STAFF REPORT

RZ/FDP 2003-PR-009

APPLICANT: Uniwest Group, LLC

PROPOSAL: Request to rezone 7.48 acres from the I-5 and HC Districts to the PRM and HC Districts. The Conceptual/Final Development Plan depicts two buildings consisting of 327,518 square feet of multi-family residential uses (265 dwelling units, including 9 affordable dwelling units) and 105,500 square feet of retail uses for a total of 433,018 square feet.

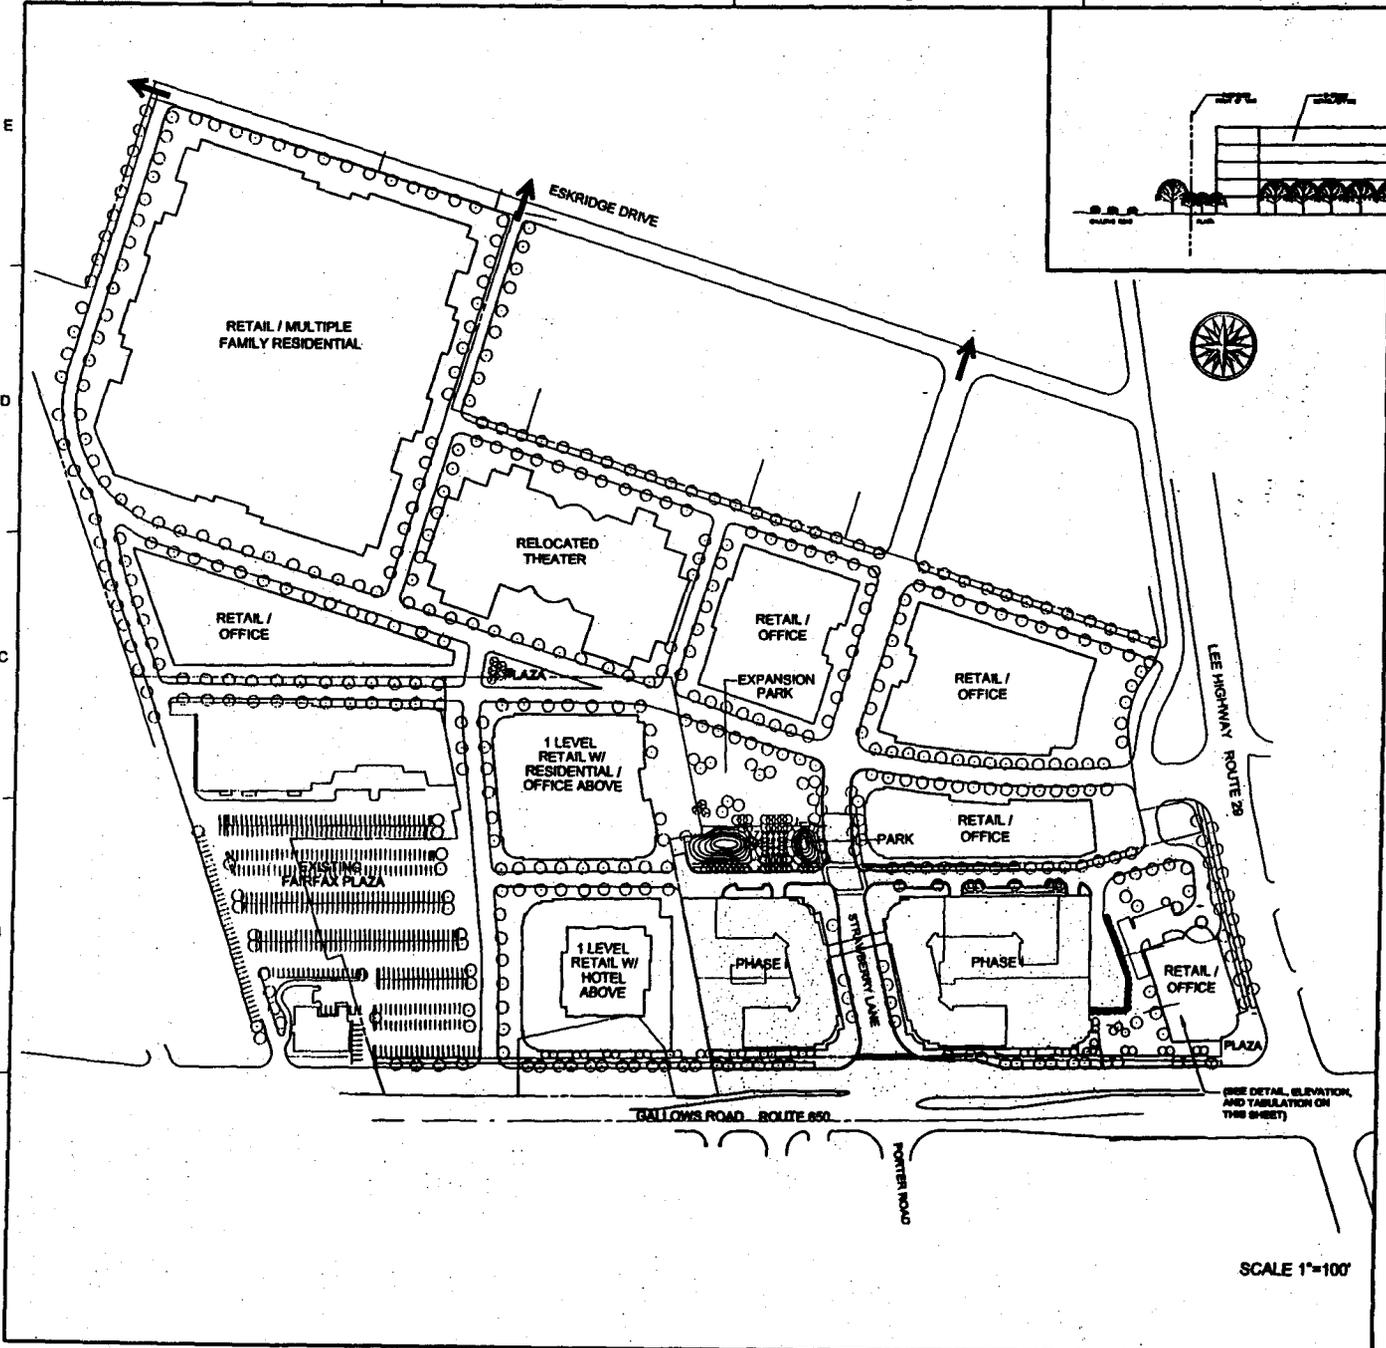
The application proposes a consolidation of land area totaling 7.48 acres which falls short of the Plan recommendation. Sheet 4 of the development proposal provides a conceptual layout which attempts to illustrate how the surrounding, unconsolidated areas could redevelop as part of a Merrifield "Town Center". Of particular concern is the failure to consolidate those adjacent parcels to the northeast, at the corner of Rt. 29 and Gallows Road. The proposed design exposes a major loading/utility area which has been designed along the development's northern edge. Redevelopment for the town center area should include a high quality image at this very visible corner since it represents the entrance and transition into the future town center planned for Sub-units F-1 and F-2. The extent to which future planned road improvements impact the existing parcels and development at the Gallows Rd./Rt. 29 intersection is not clear. Absent consolidation of properties in this northeastern corner of the sub-unit, the potential to ensure a high quality design and a strong visual focus on this area is greatly diminished.

PARK DETAIL
SCALE: 1" = 30'

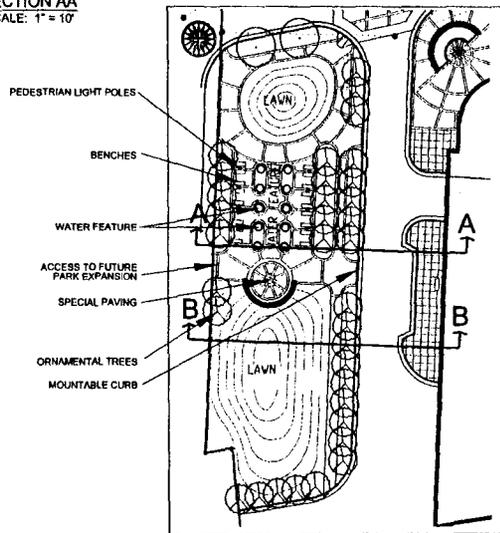
Recreation proffer 2 states that the applicant shall construct the improvements in the Urban Park as detailed on sheet 12. The correct reference is sheet 13. FCPA also requests several design changes including orientation of the park toward the future park expansion to the west, providing signage as an FCPA park maintained by the applicant, and adding a mountable curb along one portion of the park.
